REVIEW COMMENTS ON SHEETS 4, 5 AND 13  
AND RESUBMIT THROUGH THE PERMIT  
CENTER WITH REVISION APPLICATION  
COMPLETED WITH REVISION FORM

## ***Structural Calculations***

Red Dot Corporation  
Environmental Chamber Framing Re-Use  
2220760.20

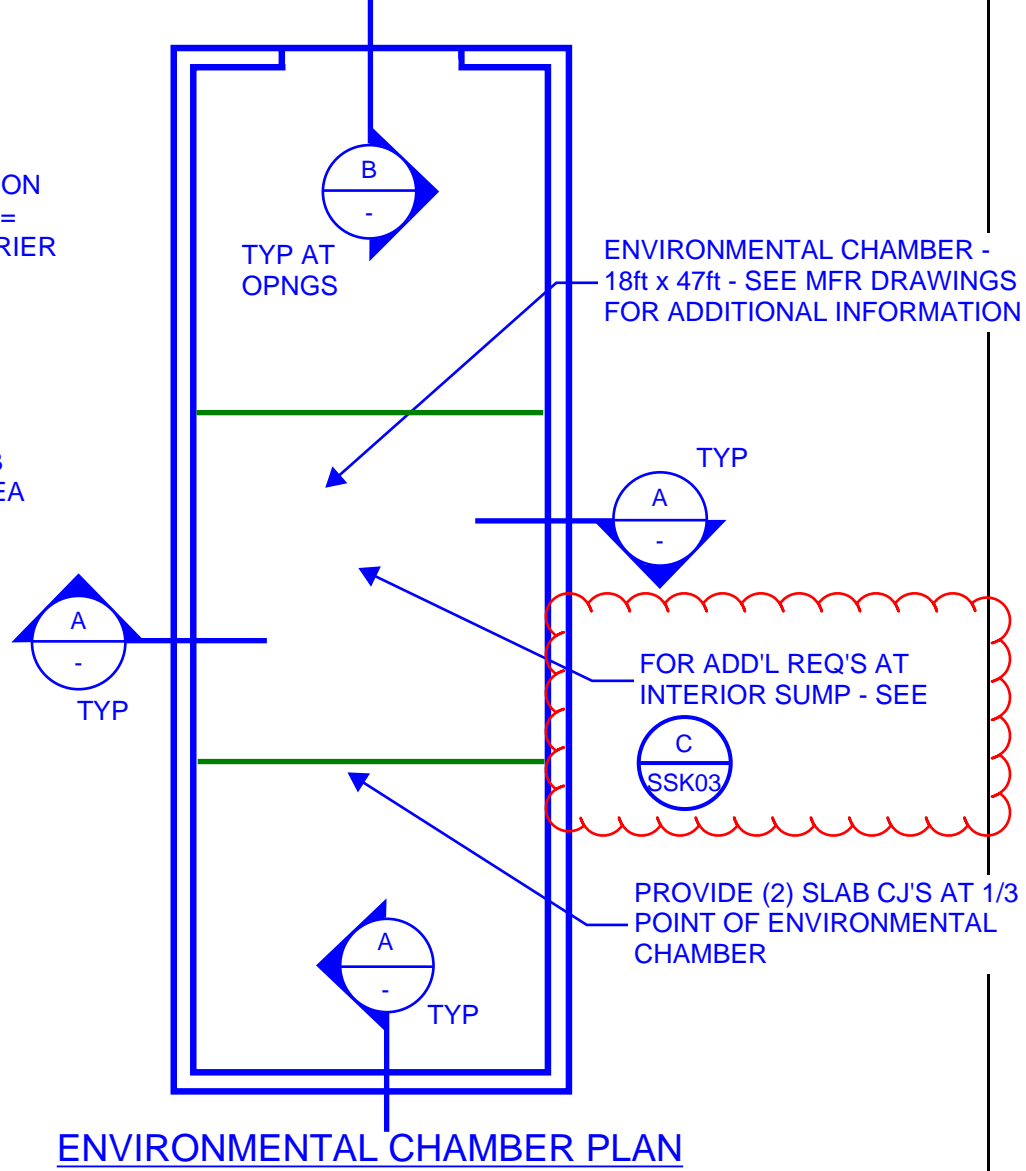
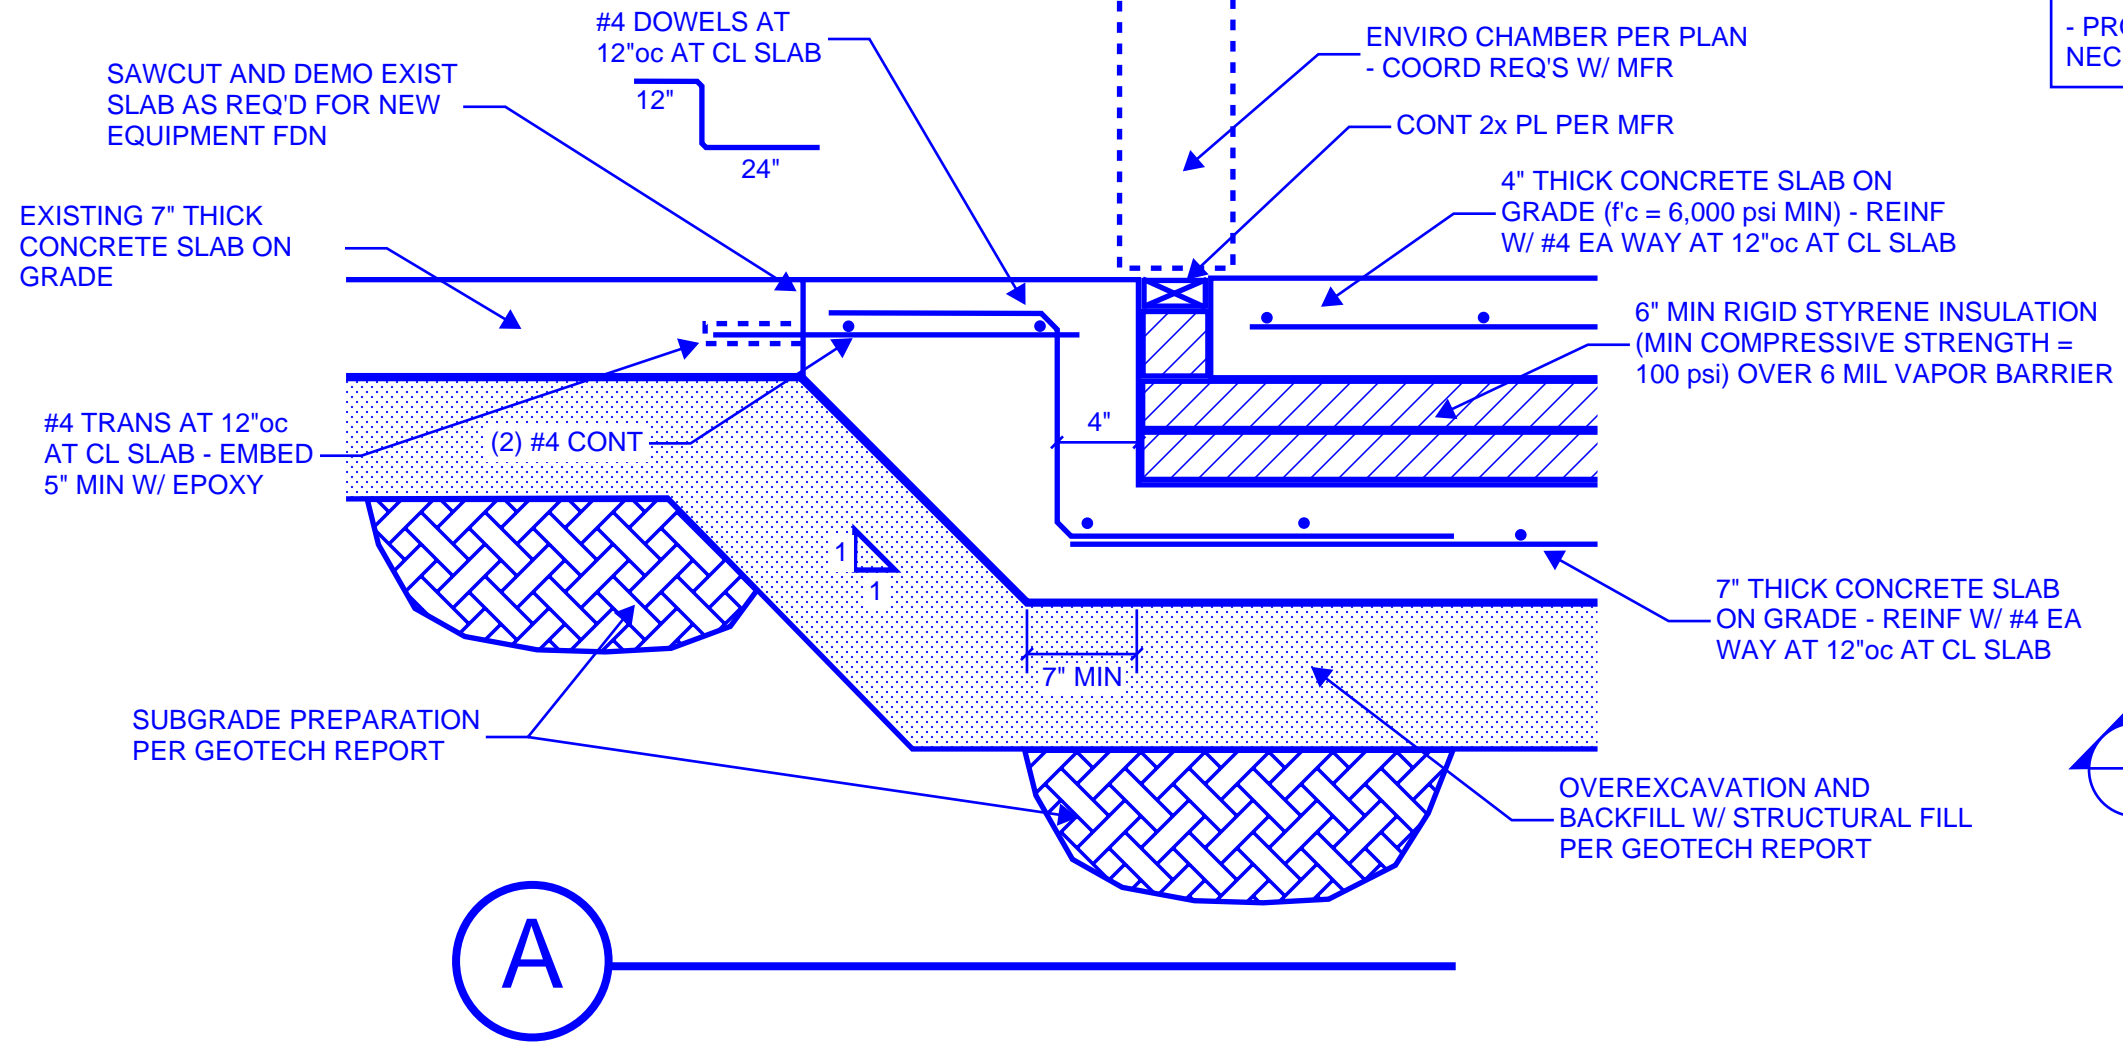
Provide complete detail how L 4 x 4 members will be used to connect panel bases to concrete. Provide location and number with type of brackets if utilized. Page 4 of 31

Provide detail how cam locks will be used at each panel joints include location and number to be installed. Page 4 of 31

**SSK-02**

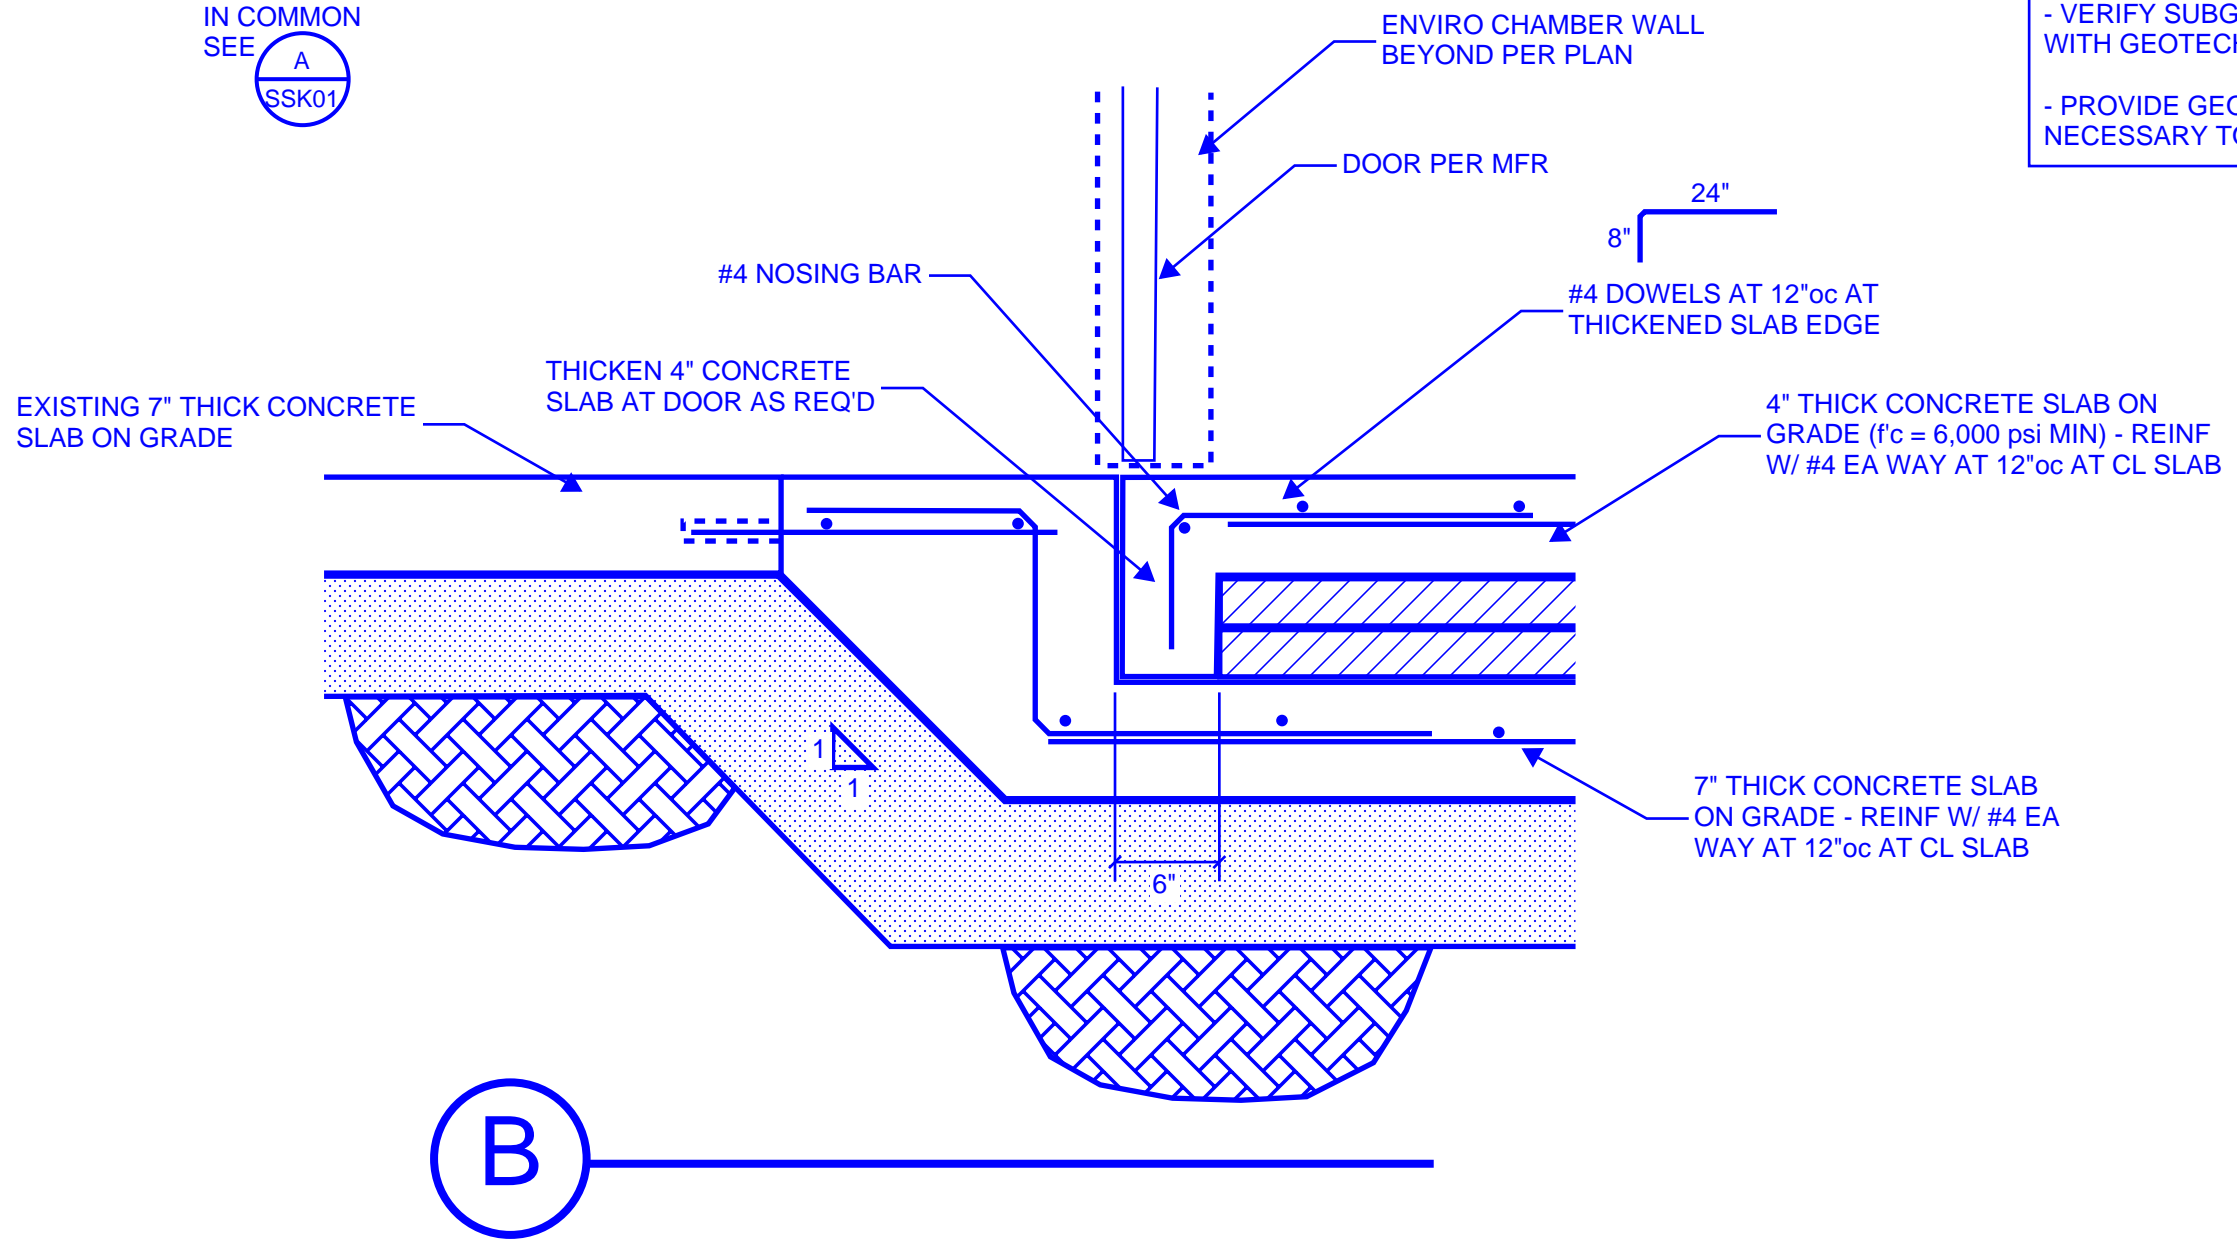
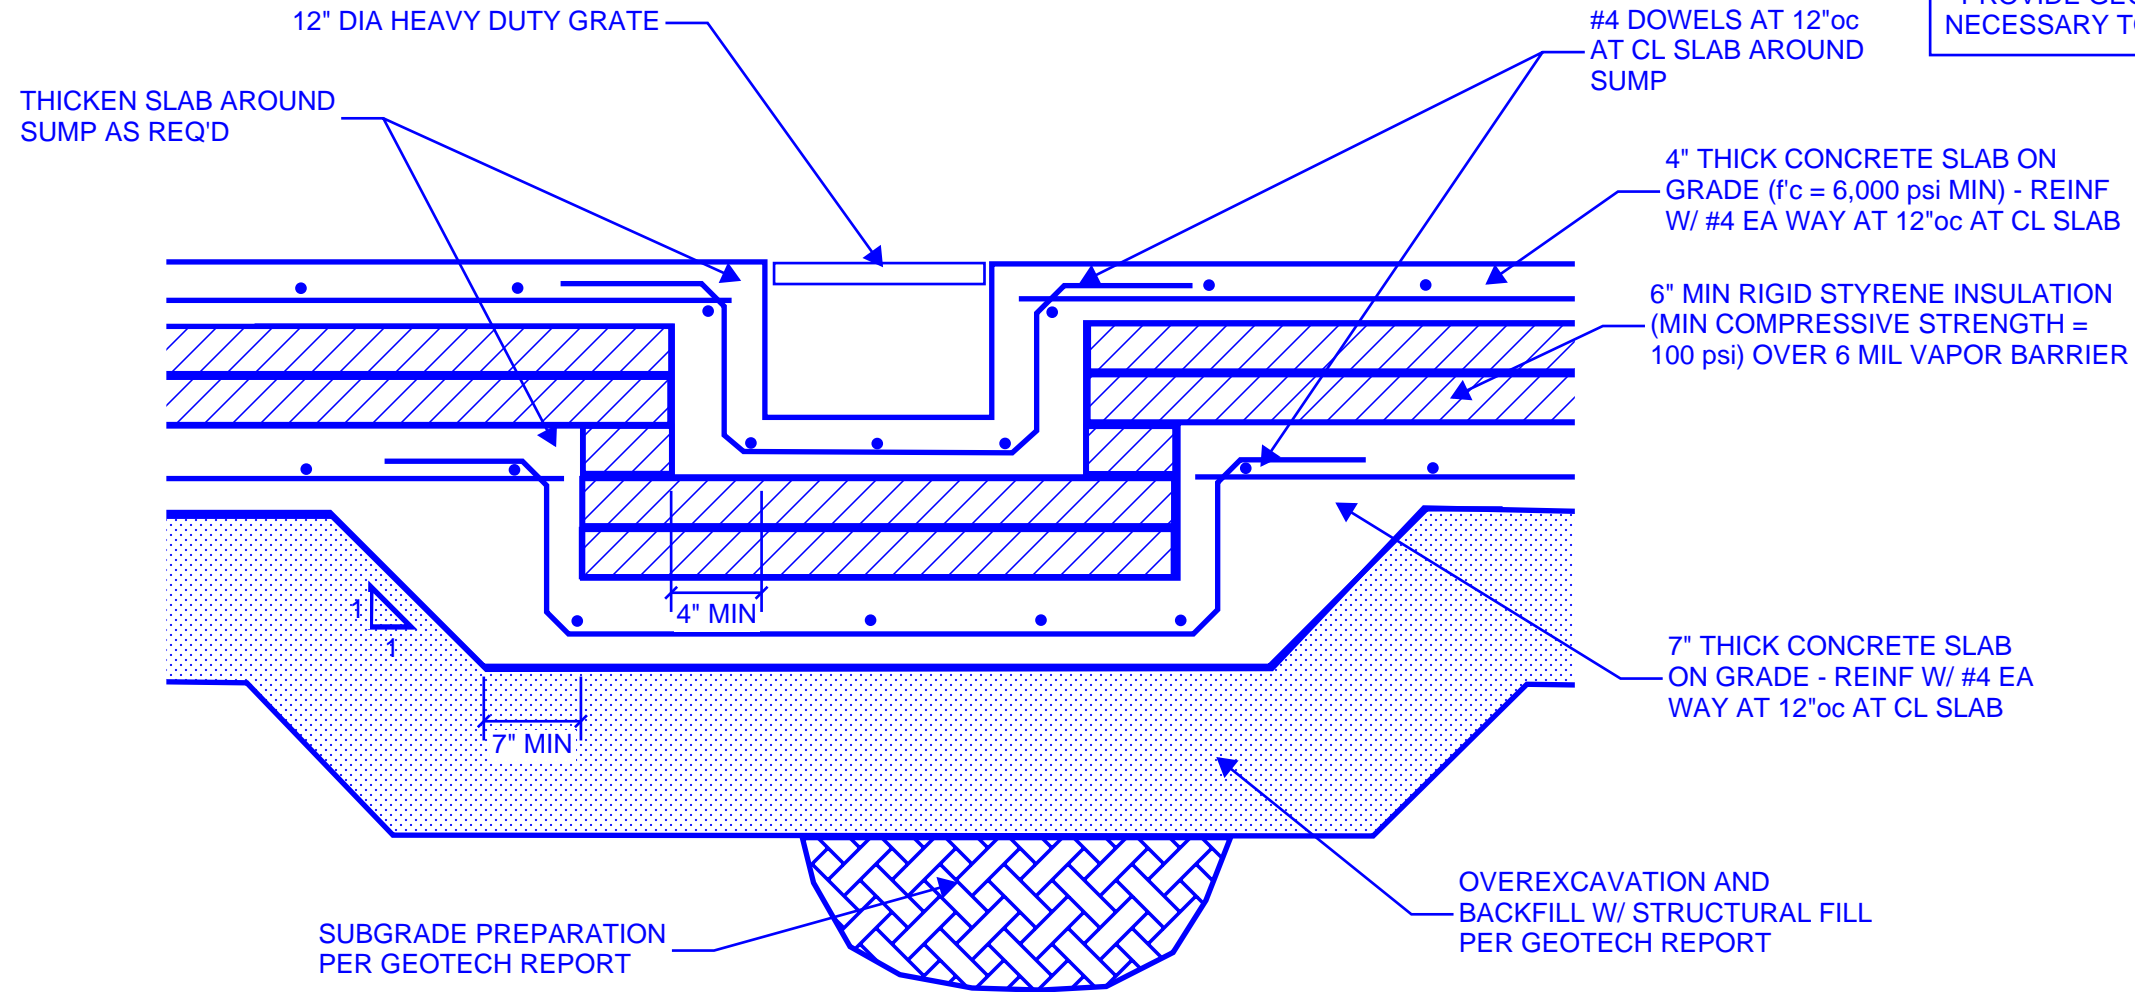
Engineer report is for foundation only. Provide complete anchorage details for environmental chamber for installation and inspections of re-locating to new facility. (detail on page 4 of 31 does not provide complete design.)  
 General notes reference installation to manufactures specification for dimensions and other items. Provide manufactures specification or remove from all sheets as unavailable to reference. Page SSK-01
